**ZONING AMENDMENT,**  
**PLANNED UNIT DEVELOPMENT &**  
**SUBDIVISION STAFF REPORT**

**Date: April 3, 2008**

<b><u>NAME</u></b>	Ben M. Radcliff Contractor, Inc.
<b><u>SUBDIVISION NAME</u></b>	Ben Radcliff Subdivision
<b><u>LOCATION</u></b>	3456 Halls Mill Road (Northwest corner of Halls Mill Road and West I-65 Service Road South, extending to the West side of West I-65 Service Road South, 500'± North of Halls Mill Road, and extending to the East side of Montlimar Creek)
<b><u>CITY COUNCIL DISTRICT</u></b>	District 4
<b><u>PRESENT ZONING</u></b>	R-1, Single-Family Residential
<b><u>PROPOSED ZONING</u></b>	I-1, Light Industry
<b><u>AREA OF PROPERTY</u></b>	3-lots/28.9± Acres
<b><u>CONTEMPLATED USE</u></b>	<p>Subdivision approval to create three lots of record, Planned Unit Development Approval to allow multiple buildings on a single building site, and Rezoning from R-1, Single-Family Residential, to I-1, Light Industry, for unspecified light industrial purposes.</p> <p><b>It should be noted, however, that any use permitted in the proposed district would be allowed at this location if the zoning is changed. Furthermore, the Planning Commission may consider zoning classifications ot

## DETAIL SITE PLAN

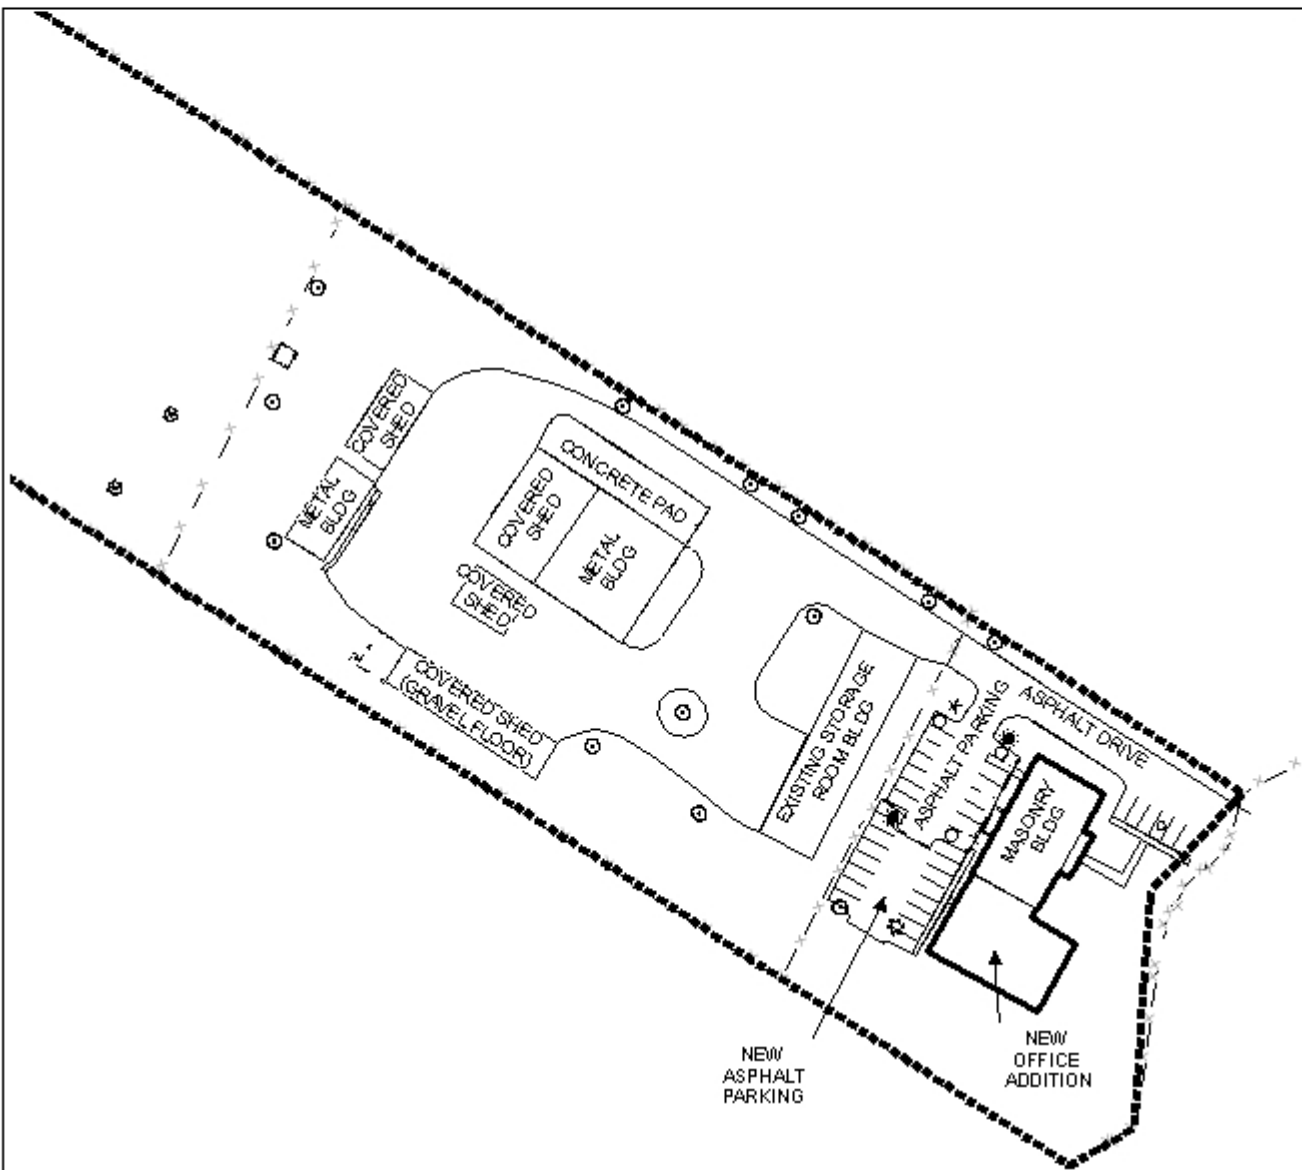
The proposed site/layout plan (Lot 3) indicates the buildings, parking area and maneuvering layout and heavy equipment laydown area. The site plan does not reflect the curb cuts that are existing, however, Lots 2 and 3 should be allowed two curb cuts to Halls Mill Road/West I-65 Service Road South, and Lot 1 one curb cut to West I-65 Service Road South, with the size, design and location to be approved by Traffic Engineering and conform to AASHTO standards.

No on-site storm water detention facilities are depicted on the site plan, however such facilities may be required due to the extent of the proposed development.

There is no indication on the site plan as to the proposed location of any dumpster or other waste storage facility. The location of the storage area for the dumpster must be indicated on the site plan, and the location and required screening must comply with Section 64-4.D.9. of the Zoning Ordinance, as well as with all other applicable regulations.

The 25-foot minimum building setback line, required in Section V.D.9. of the Subdivision Regulations is not shown on the preliminary plat. Due to the street right-of-way dedication previously stated, the minimum building setback line should be revised to reflect these requirements, and should be depicted on both the site plan and the plat.

- 1) revision of the site plan to depict proposed dumpster storage locations, in compliance with Section 64-4.D.9. of the Zoning Ordinance;
- 2) revision of the site plan to depict existing on-site circulation and parking;

- 3) placement of a note on the site plan stating that lighting shall be so arranged that the source of light does not shine directly into adjacent residential properties or into traffic;

- 4) revision of the site plan and plat to provide a minimum right-of-way width of 35 feet, as measured from the centerline for Halls Mill Road, in compliance with Section V.B.14. of the Subdivision Regulations;

- 5) revision of the site plan and plat to provide a minimum right-of-way width of 150 feet, as measured from the centerline of Interstate 65, in compliance with Section V.B.14. of the Subdivision Regulations;

- 6) revision of the site plan to accurately depict all existing curb-cuts, and modifications thereof (with reduction of excessive width curb-cuts where possible), as well as proposed curb-cuts;

- 7) depiction of a 6-foot high solid wooden fence and 10-foot vegetative buffer, where the site abuts Montlimar Creek;
- 8) revision of the site plan to provide full compliance of the landscaping and tree requirements of the Ordinance for the entire site; and
